An Analysis of “Bujagali II – Economic and Financial Evaluation Study – Final Reports” by Power Planning Associates

By Pete Tsournos, Associate Professor, Department of Economics, California State University - Chico

The stated purpose of the study by Power Planning Associates, which was commissioned by the World Bank Group, is to evaluate the economic viability of the proposed Bujagali project in Uganda, while taking into account the economic, financial, social, and environmental aspects. International Rivers Network asked economist Pete Tsournos to analyze the report against a few key questions.

Lake Victoria and The Proposed Hydrological Curve Change

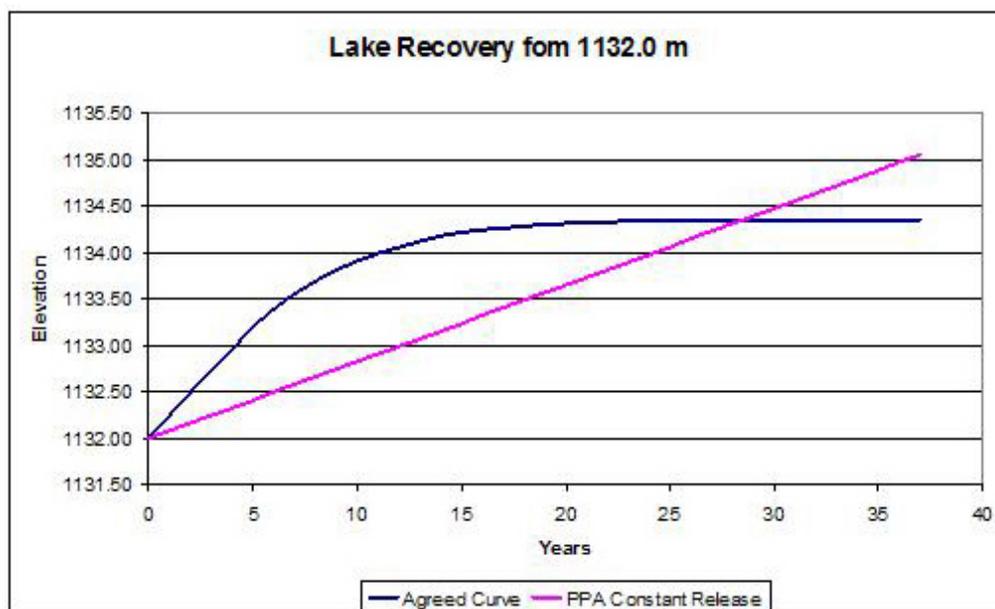
The graph above shows that the Agreed Curve allows the lake level to recover more quickly than with the PPA proposed outflow regime. The graph looks at how Lake Victoria would recover from a baseline level of 1132.0 m (a low level that was experienced late last year) during 35 years of constant average inflow (average net basin supply "NBS" 1900-2005 computed in the PPA report). As the graph shows, the Agreed Curve releases would restore the lake to a relatively "normal" level within about six years, while the Constant Release flow will not reach that level for close to 18 years. The Agreed Curve response is more representative of a naturally functioning lake, as opposed to the PPA regime, which resembles the filling of a reservoir.
